**To:** Jason Boyle, Minnesota Department of Natural Resources (MDNR)  
**Prepared for:** Poly Met Mining, Inc.  
**From:** Tom Radue, P.E.  
**Subject:** Tailings Basin Cell 2E North Dam – Modified Buttress as Alternative to Cement Deep Soil Mix Zone  
**Date:** December 30, 2016  
**c:** Jennifer Saran (PolyMet)

### **Cell 2E North Dam Geometry Modifications and Slope Stability**

| DWG. No.<br><b>FIGURE 1</b>              | REV. No.<br><b>A</b> |

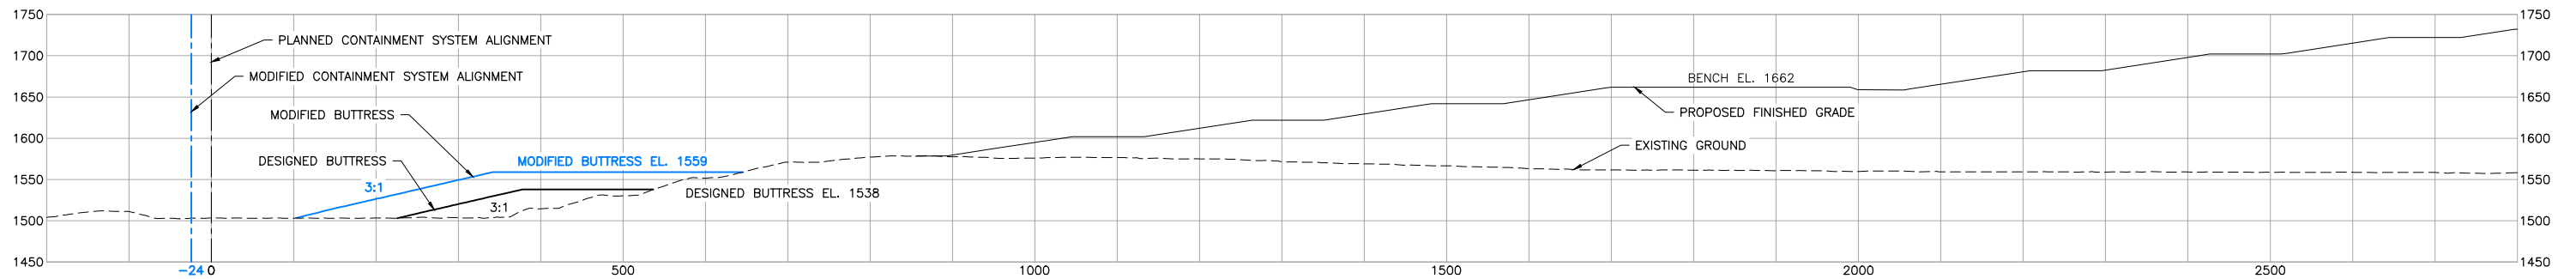
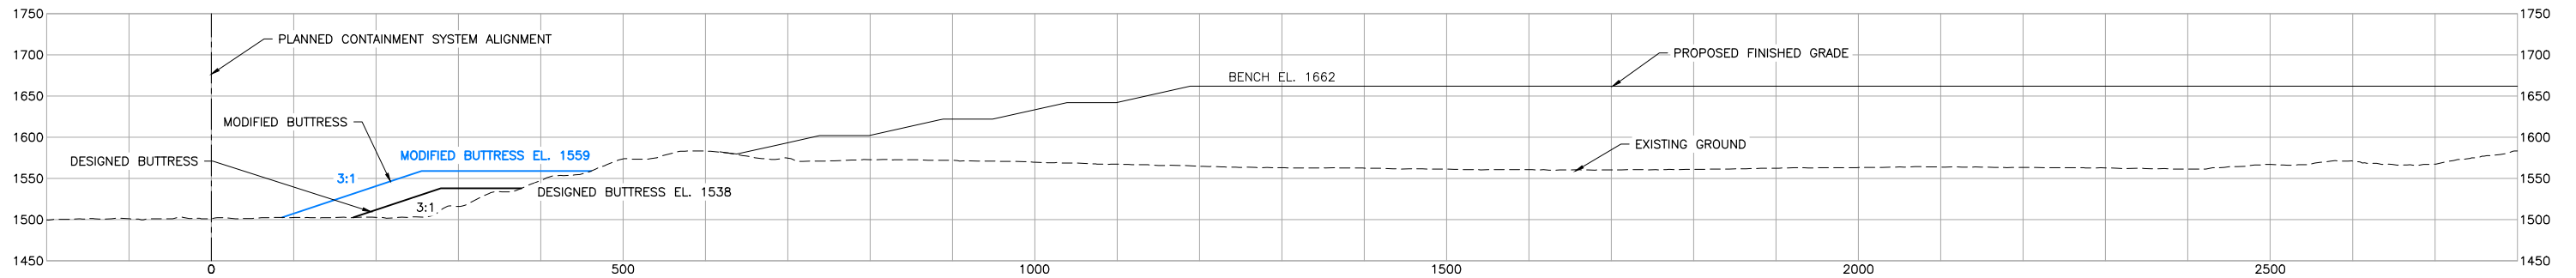
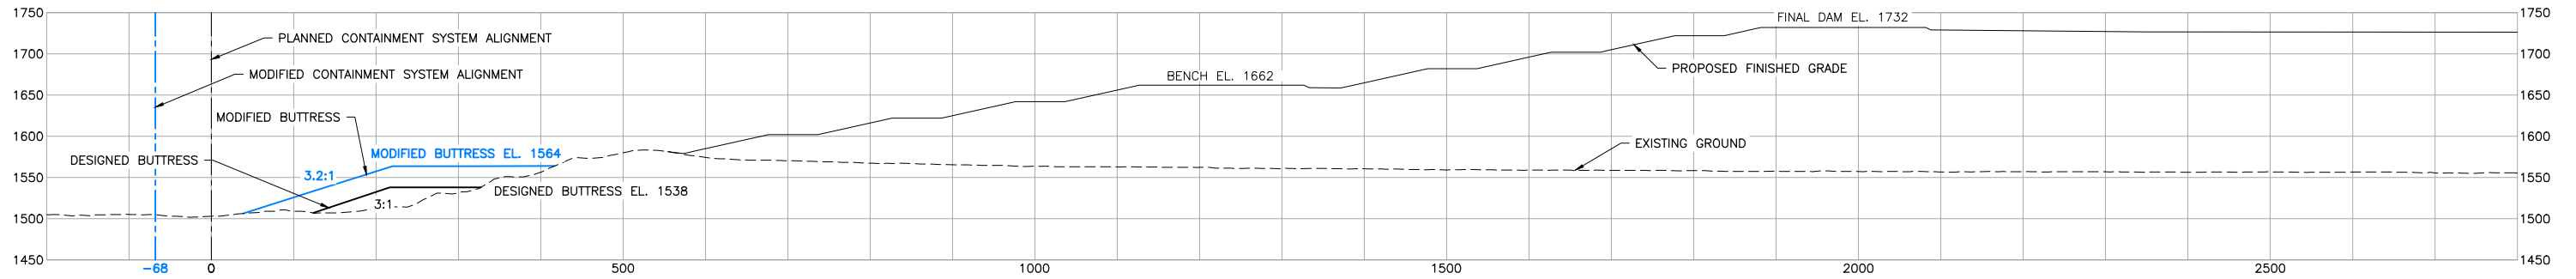
Figures 1 through 3 show the Cell 2E North Dam buttress in plan and cross-section:

- as proposed in the Dam Safety Permit Application
- with a modified buttress as an alternative to the CDSM

For the modified buttress, the northern toe of the buttress shifts northward a maximum of 107 feet. To accommodate this shift, the seepage containment system alignment also shifts northward, between Stations 176+50 and 208+00 and between Stations 218+80 to 240+00. For the western portion of the buttress, the top elevation increases to 1574 from the previous 1538, and for the eastern portion of the buttress, the top elevation increases to 1559 from the previous 1538. A transition zone connects these western and eastern buttress sections. With the modified buttress, exterior slope would vary between 3H:1V and 3.5H:1V, as compared to the 3H:1V buttress slope; in some areas the buttress slope would become flatter than currently proposed.

# Figure 4 Future Dam Configuration\_Section F\_Inactive

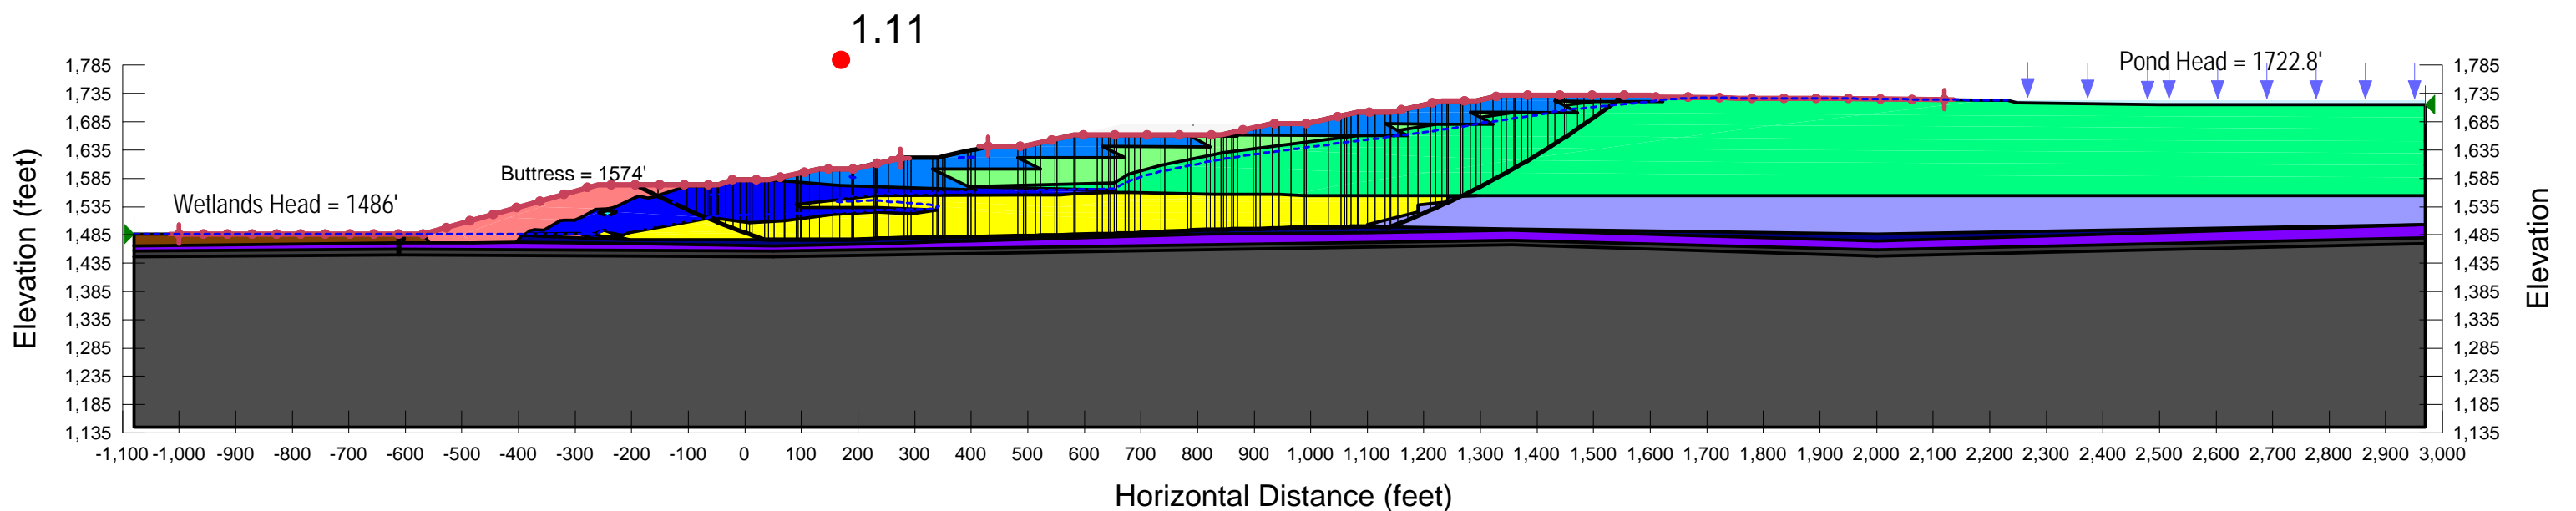
| Figure No. | Slope Section Modeled | Slope Condition Modeled   | Required Slope Stability Factor of Safety (FOS) | Slope Stability Factor of Safety (FOS) Model Outcome | Slope Stability FOS Equal to or Greater Than Required FOS Yes/No |
|------------|-----------------------|---|---|--|--|
| 4          | Section F             | Lift 8 with Modified Buttress – USSA <sub>liq</sub> , Seepage Containment System Inactive | FOS $\geq$ 1.10                                 | FOS = 1.11   | Yes  |

# Figure 5 Future Dam Configuration\_Section F\_Active All Saturated Contractive Soils Liquefied to USSRliq

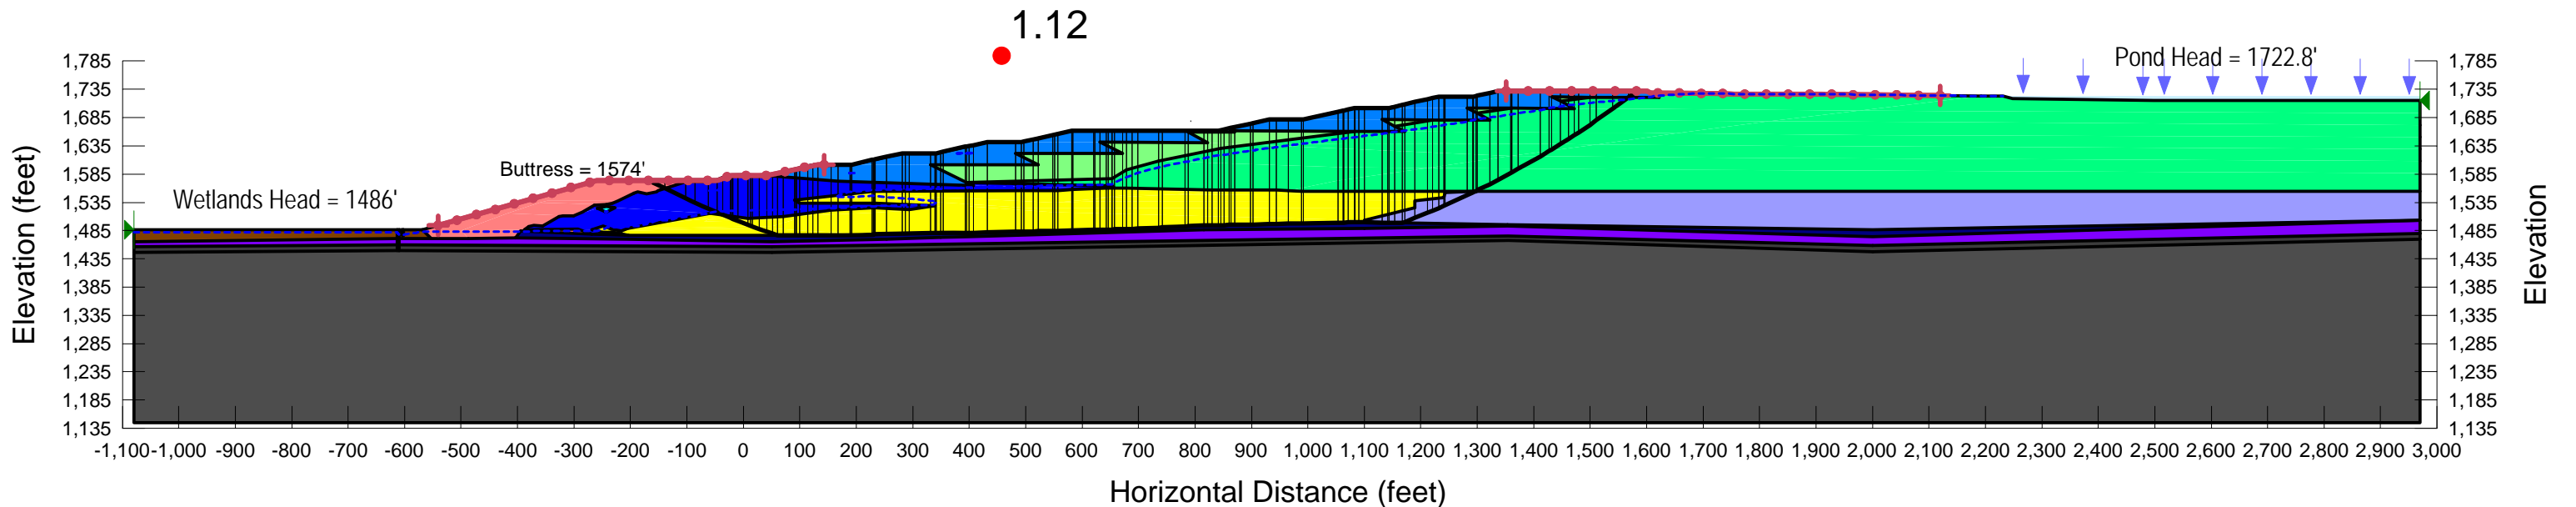
| Figure No. | Slope Section Modeled | Slope Condition Modeled   | Required Slope Stability Factor of Safety (FOS) | Slope Stability Factor of Safety (FOS) Model Outcome | Slope Stability FOS Equal to or Greater Than Required FOS Yes/No |
|------------|-----------------------|---|---|--|--|
| 5          | Section F             | Lift 8 with Modified Buttress – USSA <sub>liq</sub> , Seepage Containment System Active   | FOS $\geq$ 1.10                                 | FOS = 1.12   | Yes  |

# Figure 6 Future Dam Configuration\_Section G\_Inactive

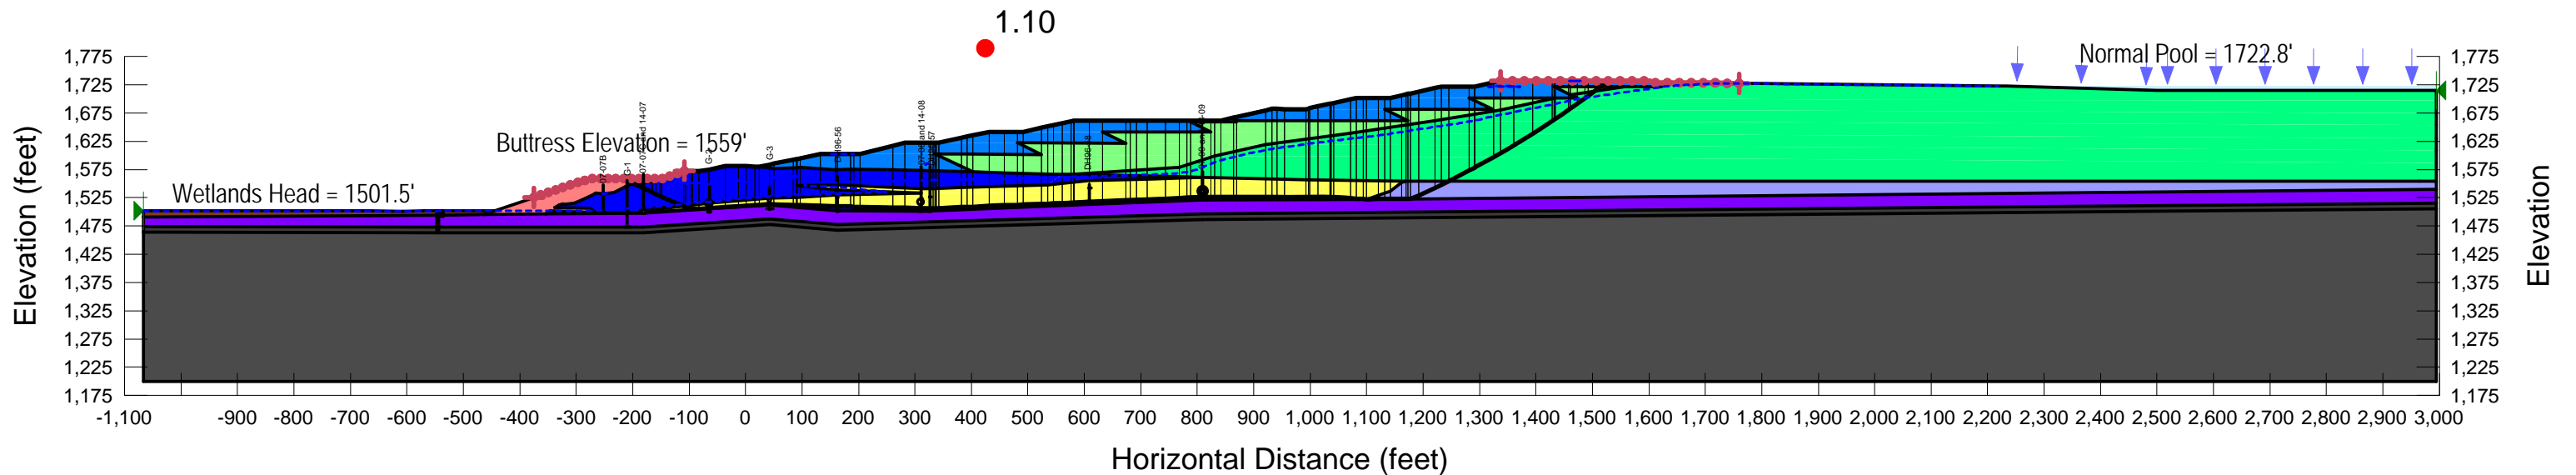
| Figure No. | Slope Section Modeled | Slope Condition Modeled   | Required Slope Stability Factor of Safety (FOS) | Slope Stability Factor of Safety (FOS) Model Outcome | Slope Stability FOS Equal to or Greater Than Required FOS Yes/No |
|------------|-----------------------|---|---|--|--|
| 6          | Section G             | Lift 8 with Modified Buttress – USSA <sub>liq</sub> , Seepage Containment System Inactive | FOS $\geq$ 1.10                                 | FOS = 1.10   | Yes  |

# Figure 7 Future Dam Configuration\_Section G\_Active

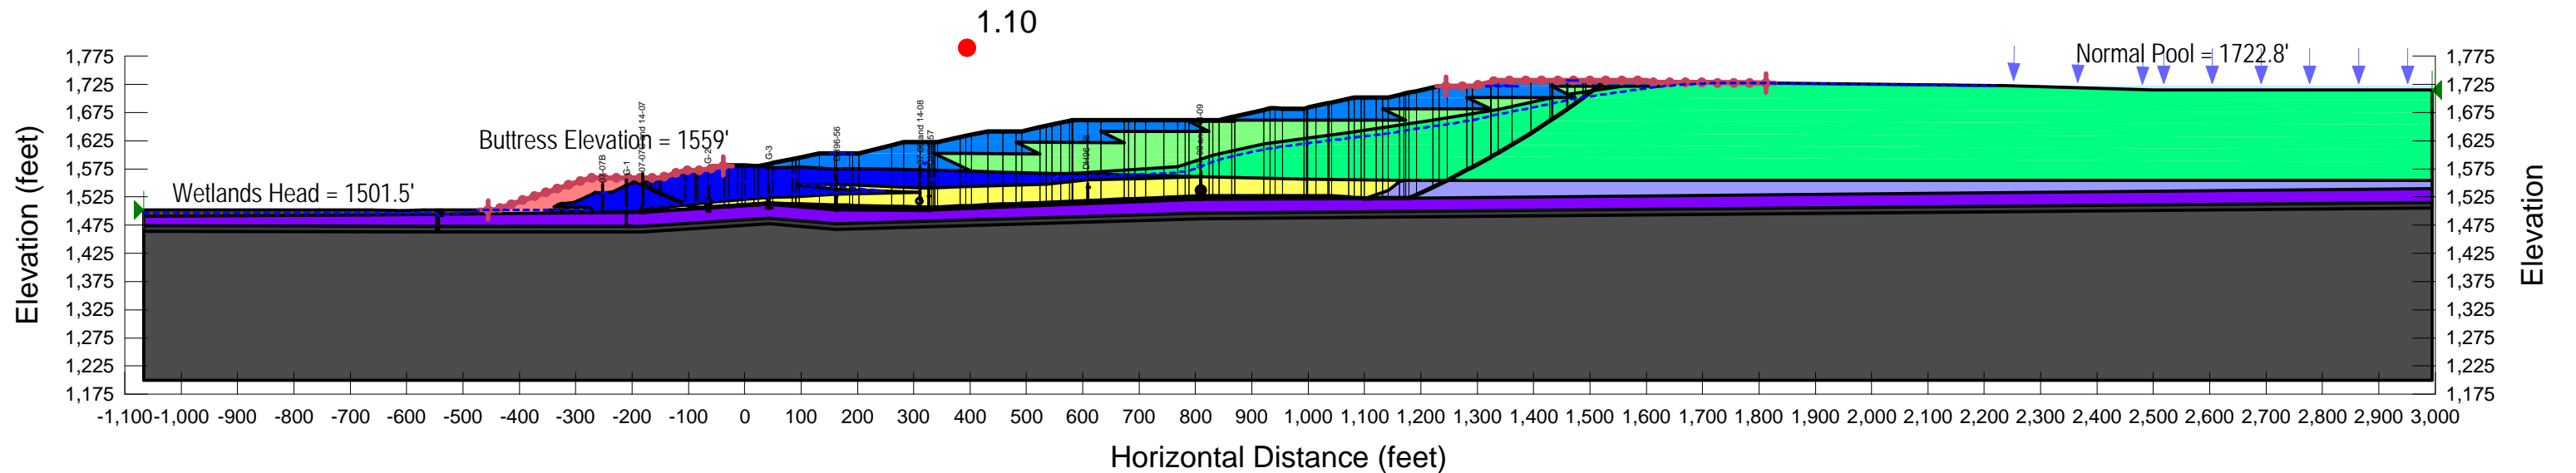
| Figure No. | Slope Section Modeled | Slope Condition Modeled   | Required Slope Stability Factor of Safety (FOS) | Slope Stability Factor of Safety (FOS) Model Outcome | Slope Stability FOS Equal to or Greater Than Required FOS Yes/No |
|------------|-----------------------|---|---|--|--|
| 7          | Section G             | Lift 8 with Modified Buttress – USSA <sub>liq</sub> , Seepage Containment System Active   | FOS $\geq$ 1.10                                 | FOS = 1.10   | Yes  |
